Subject: **16635 Yonge Street – Proposed Shoppers Drug Mart**

REVIEW NOTES

16635 YONGE STREET

Skamari Investments Inc.

DRAWING TITLE: SITE PLAN

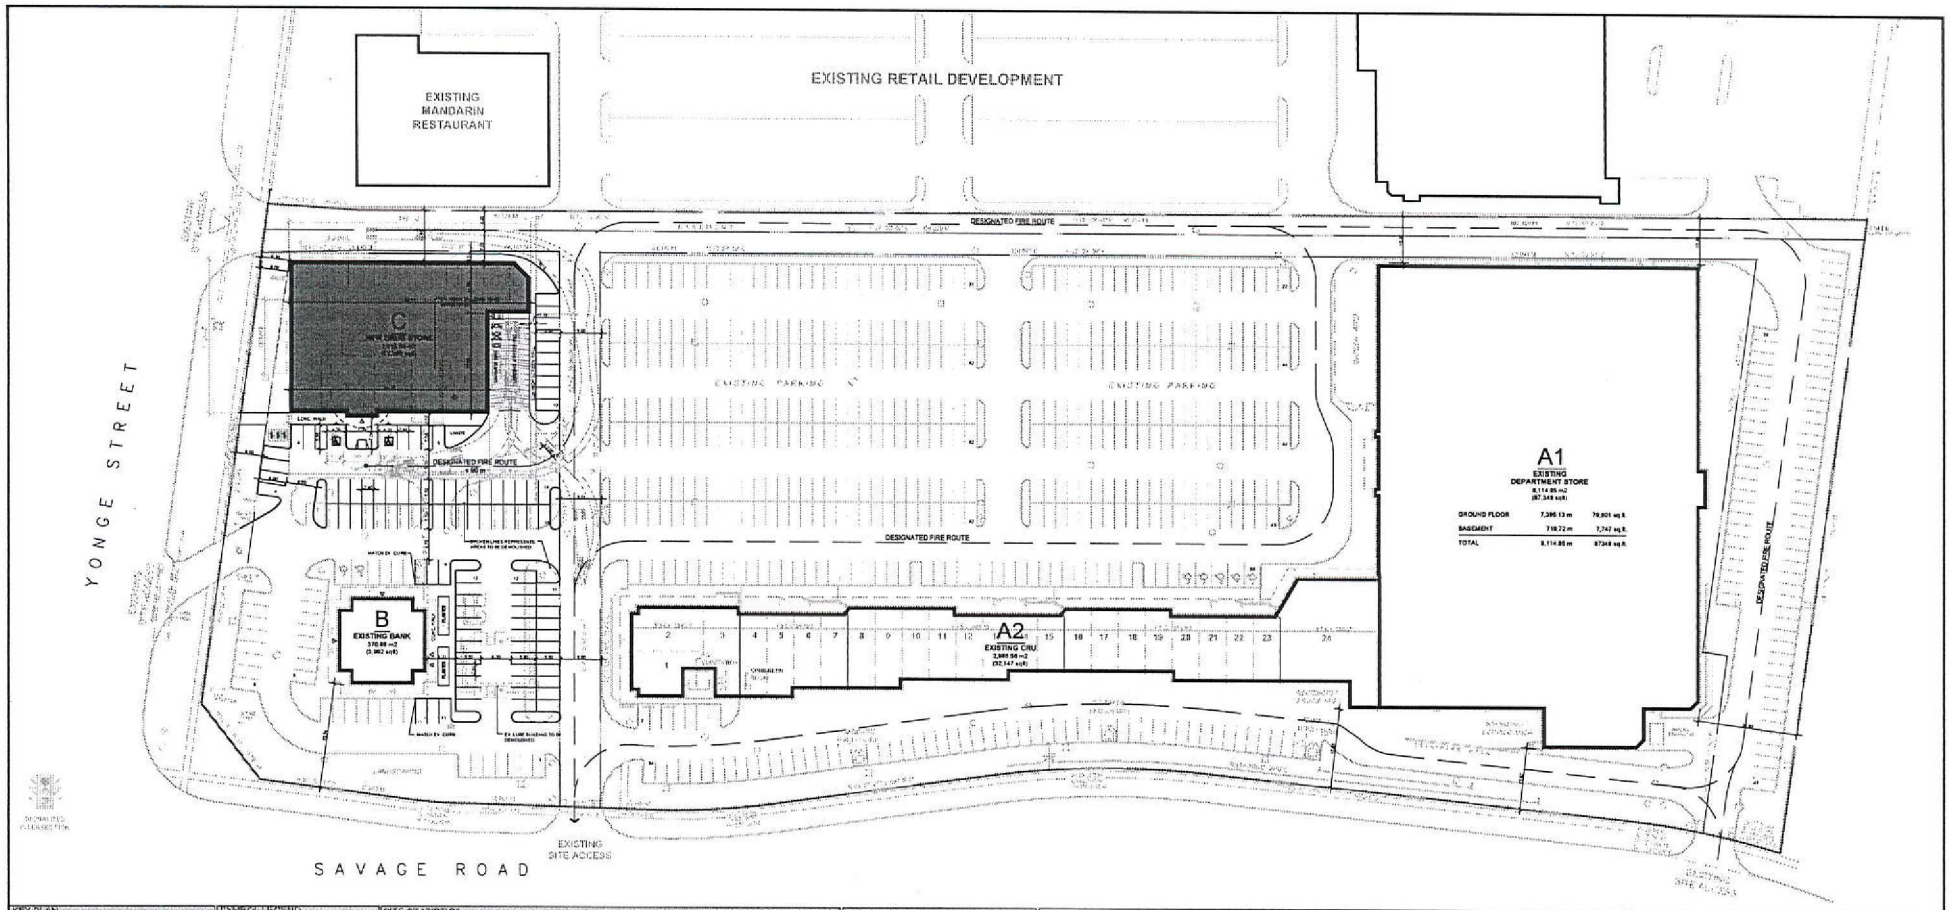
- Property is zoned Regional Urban Centre (UC-R) by By-law Number 2010-40, as amended
- Use is permitted
- Proposed building does not meet front yard setback requirement – maximum front yard setback is 6.0 metres; minimum front yard setback is 3.0 metres

- Required number of parking spaces to be confirmed – by-law does not permit surplus parking
- Site Plan to be revised to indicate current conditions on site, e.g. new parking spaces in front of call centre not shown; call centre labelled as "department store", etc.

- Landscaping to include additional plantings on property along Yonge Street
- Break up large rows of parking in front of proposed building with landscaped islands

- Ontario Building Code Data Matrix to be included on Site Plan
- Property is within Wellhead Protection Area (WHPA-B) – applicant to obtain Section 59 Notice from Region of York
